September 27, 2011

Subject: Hogan-Pancost Property: Neighborhood Event Timeline and Response to Specific Questions Raised by Adjacent Neighbors

FIGURE 2
 PRECIPITATION AND EVENT HISTORY

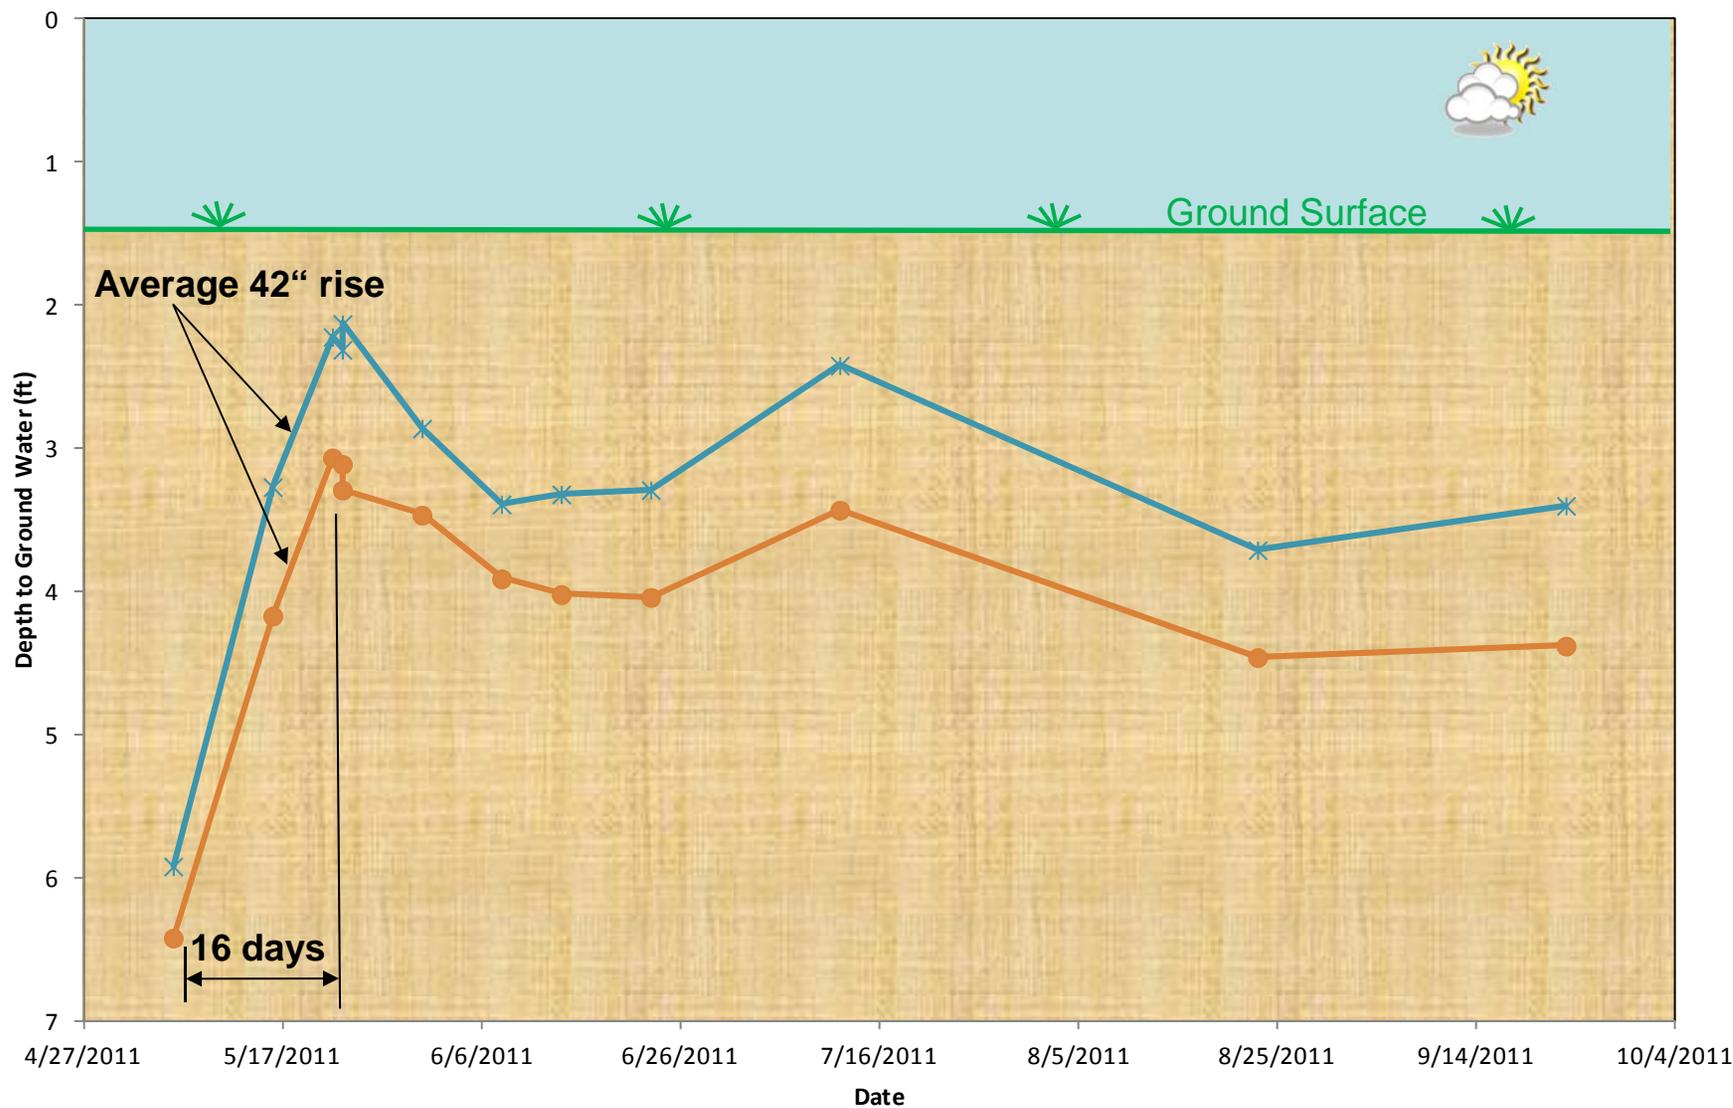
Question: The homes along Cimmaron Way were built in 1966 without basement sumps. Why did the ground water rise in July of 1990 so that sumps needed to be installed and pumping had to begin at 220, 230 & 240 Cimmaron Way?

The Short Response: Ground water levels increased in response to: 1) increased recharge from precipitation, and 2) increased recharge from lawn irrigation due to residential development in south Boulder. In 1990, the ground water levels reached a level that required basement sumps and pumping at these addresses.

The Long Response: The homes along Cimmaron Way were constructed in 1966 with basements and without basement sumps. From 1960 through 1968 the City of Boulder, and the South Boulder Creek watershed, had 6 of 9 years with below average precipitation (Figure 2). This is reflected in the spring flows (March-June) in South Boulder Creek which were 22% lower than average during the same period. At the time the homes were constructed, it is hypothesized that the ground water levels were low due to the multiple years of below average precipitation. In 1969, precipitation was significantly higher and South Boulder Creek flooded. Water from the flood recharged ground water but it was not enough to raise the ground water to a level that required sumps and pumping. Precipitation in 1970 was below average, 1971 and 1972 were near average and 1973 was above average. From 1974 through 1977 precipitation was below average and the ground water levels remained low. From 1978 to 1990 there was a trend of increasing precipitation with 8 of 13 years having higher than average precipitation.
